**Re: Addendum No. 3
WWTP NFA Improvements
City of Conneaut**

Date: August 27, 2024

THE CITY OF CONNEAUT
WASTEWATER TREATMENT PLANT
NFA IMPROVEMENTS
ASHTABULA COUNTY
CONNEAUT, OHIO

EXISTING SITE PLAN

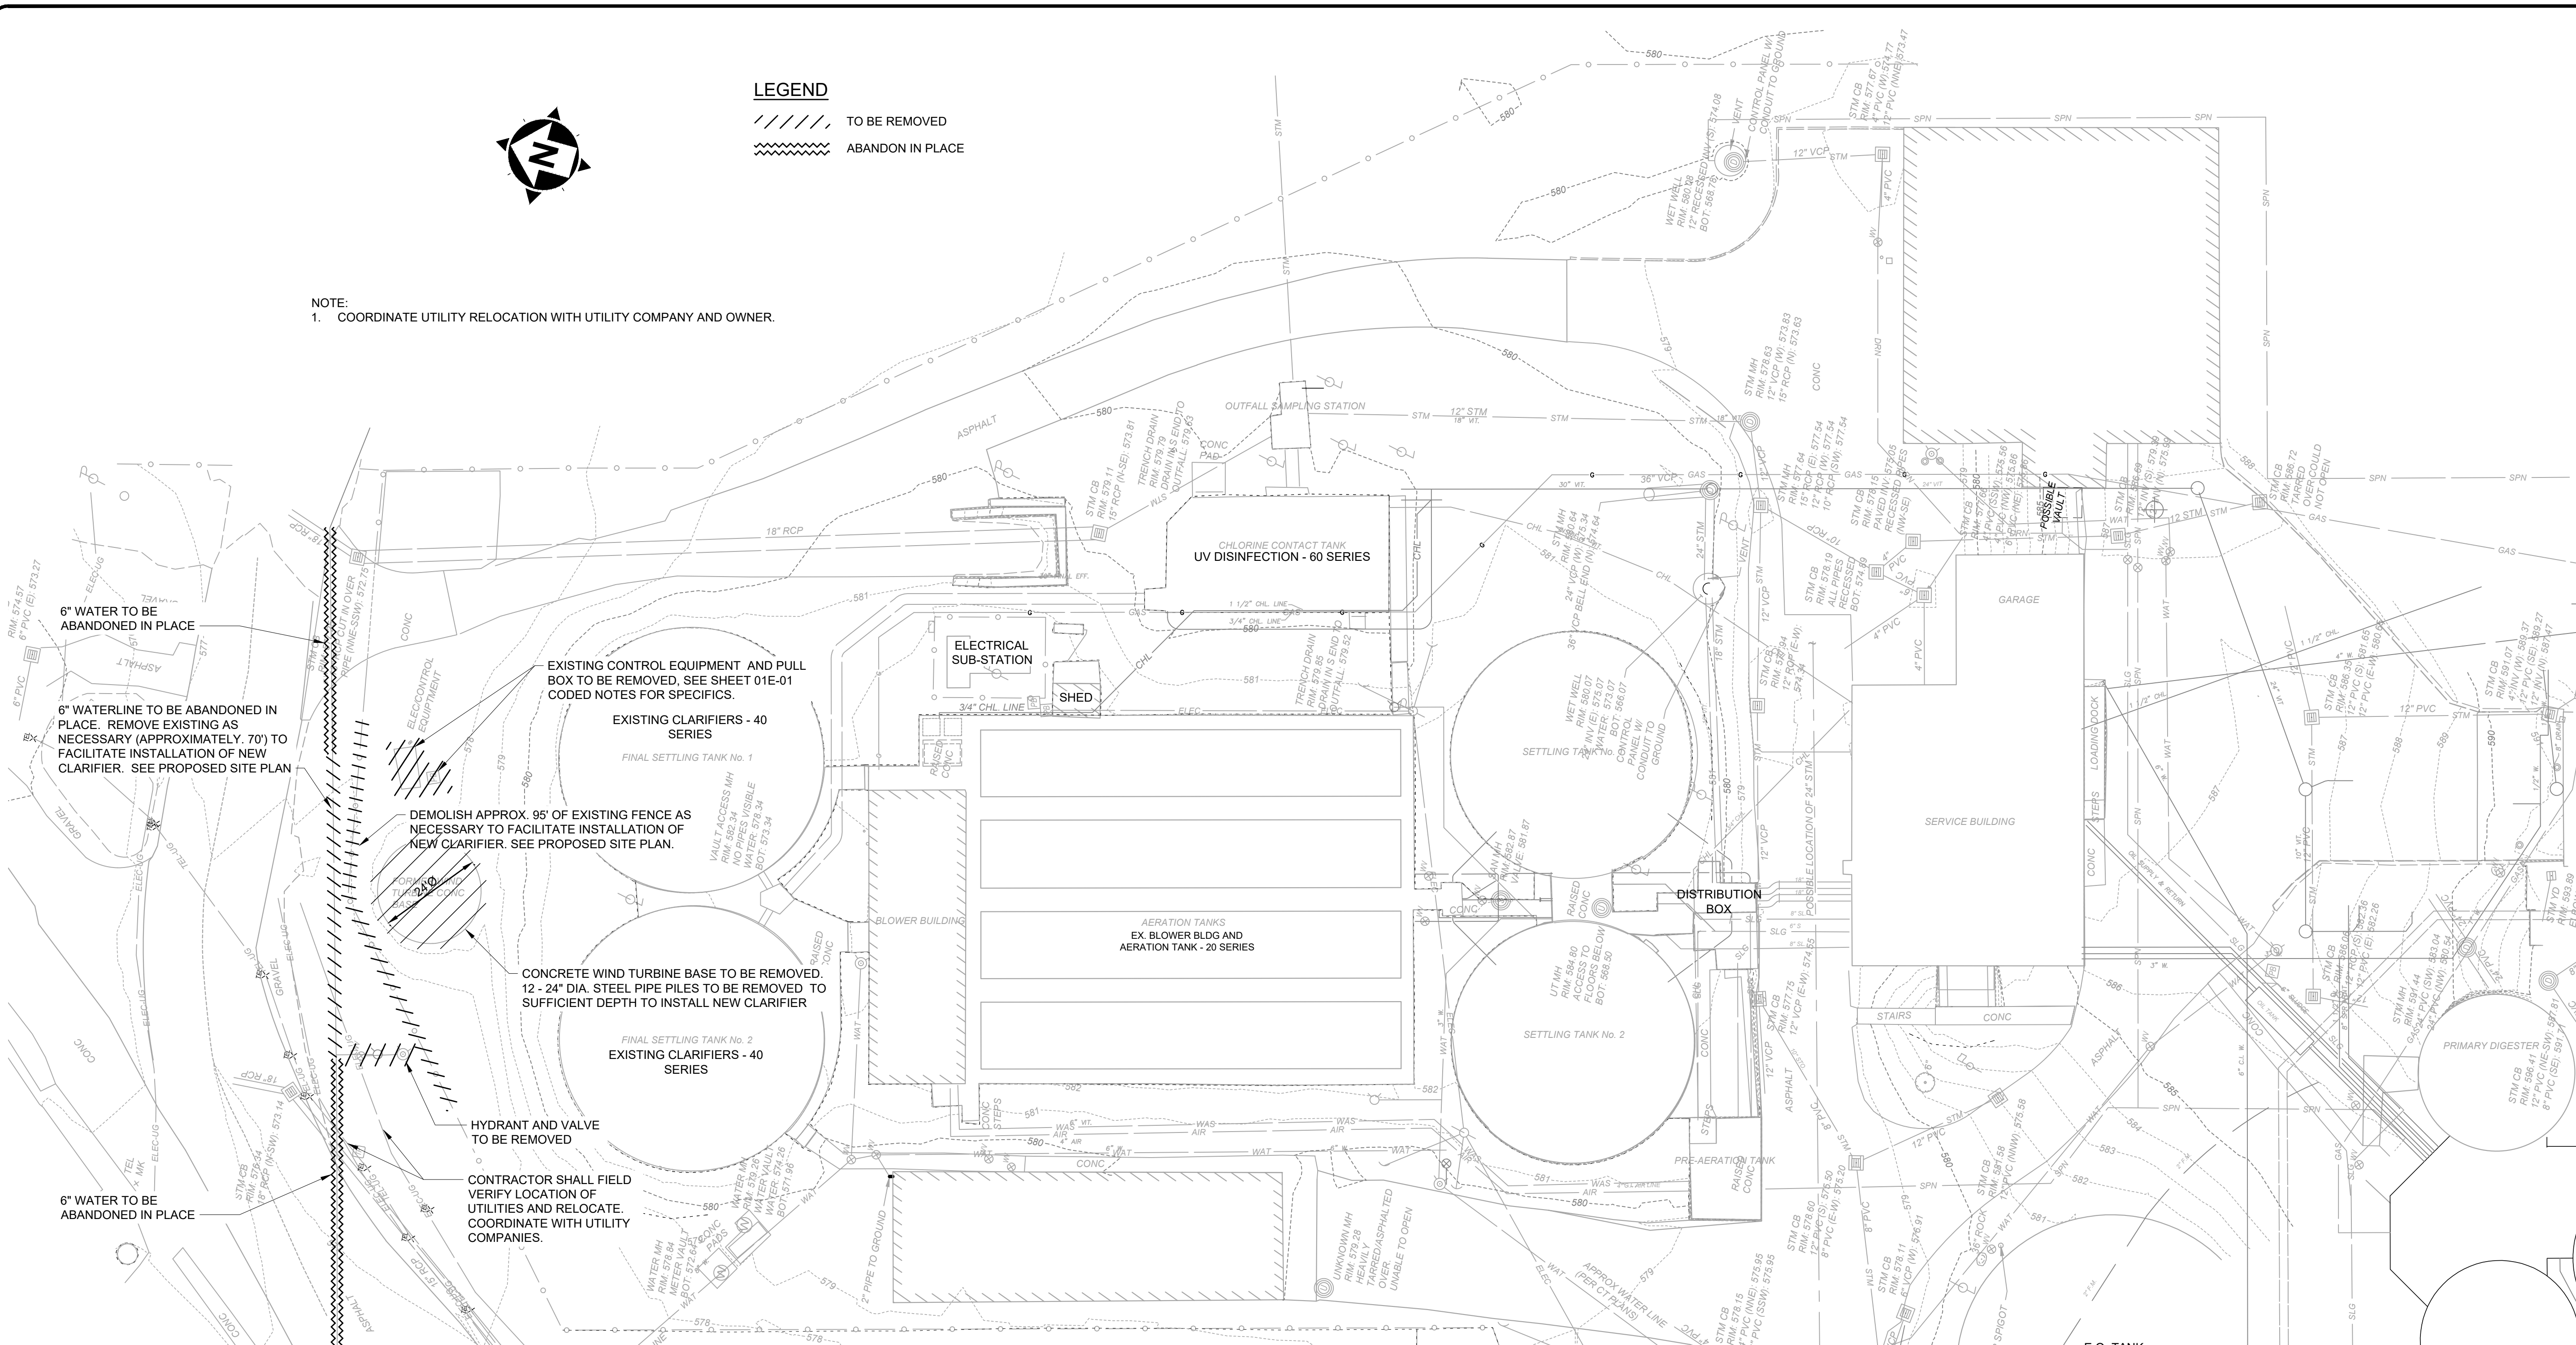
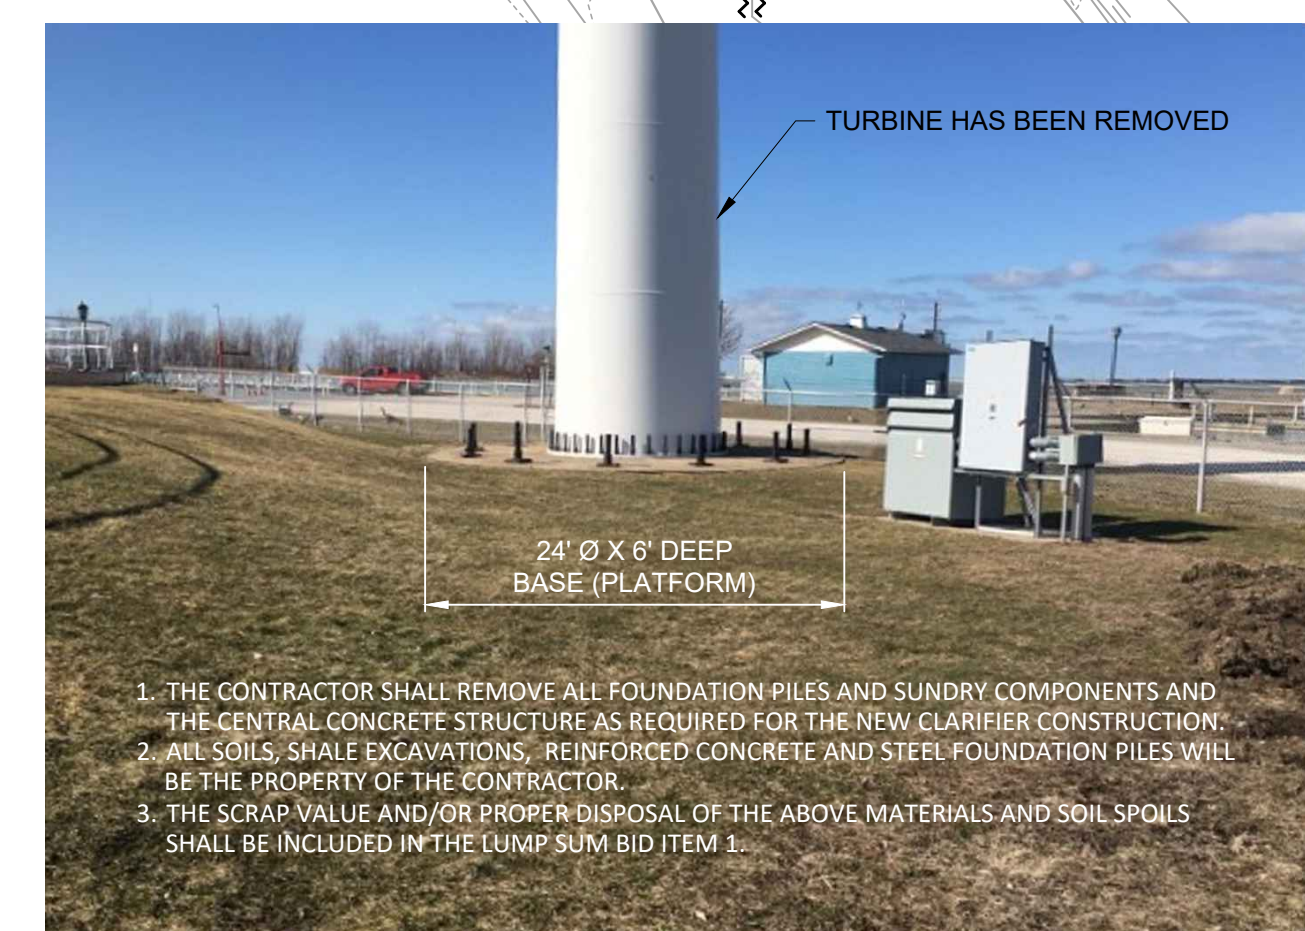
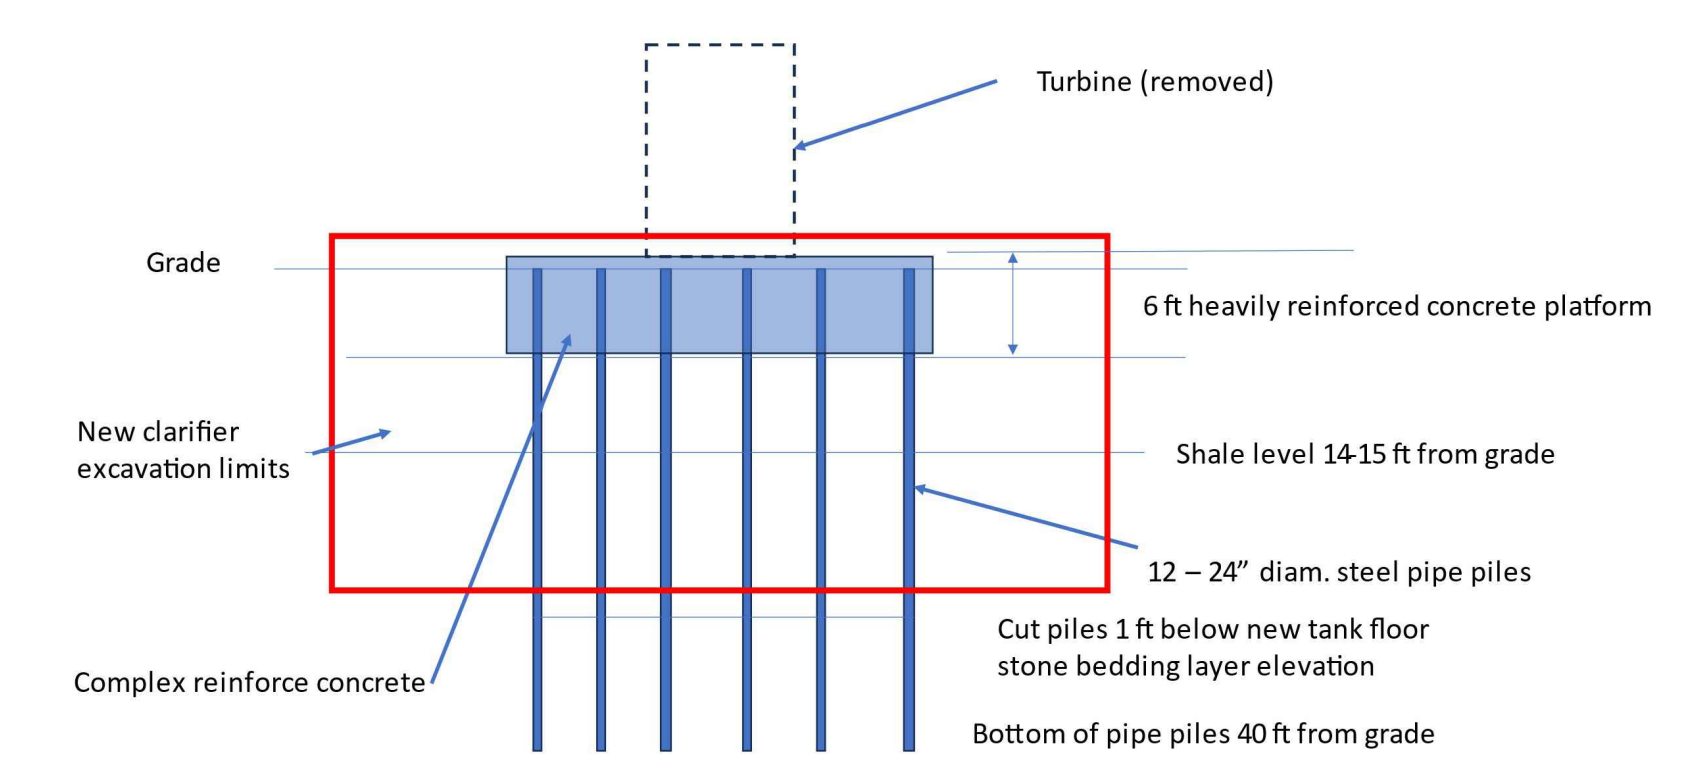
Q1. Is the old windmill transformer being removed or relocated. Can the Contractor remove all of the equipment, turn over to owner and keep the existing conduits for future use.

C1. Final Clarifier construction: Marina Dr. and at least a single lane of the road along the new clarifier site shall remain open during construction. If the contractor elects to use Temporary Earth Retention Systems (TERS) in accordance with Specification Section 310000 – Earthwork in order to maintain a single lane past the excavation, the cost shall be included in Base Bid Item 1. If the contractor elects to layback the excavation, a single lane past the excavation is still required and concrete safety barriers shall be provided along the edge of the excavation. In either case added utilities must be relocated and the site demolition of underground utilities drawing 01C-02 is being reissued.

A1. See sheet 01E-01 and enclosed 01C-02.

CONCRETE WIND TURBINE BASE TO BE REMOVED. 12 - 24" DIA. STEEL PIPE PILES TO BE REMOVED TO SUFFICIENT DEPTH TO INSTALL NEW CLARIFIER

1. THE CONTRACTOR SHALL REMOVE ALL FOUNDATION PILES AND SUNDRY COMPONENTS AND THE CENTRAL CONCRETE STRUCTURE AS REQUIRED FOR THE NEW CLARIFIER CONSTRUCTION.
2. ALL SOILS, SHALE EXCAVATIONS, REINFORCED CONCRETE AND STEEL FOUNDATION PILES WILL BE THE PROPERTY OF THE CONTRACTOR.
3. THE SCRAP VALUE AND/OR PROPER DISPOSAL OF THE ABOVE MATERIALS AND SOIL SPOILS SHALL BE INCLUDED IN THE LUMP SUM BID ITEM 1.
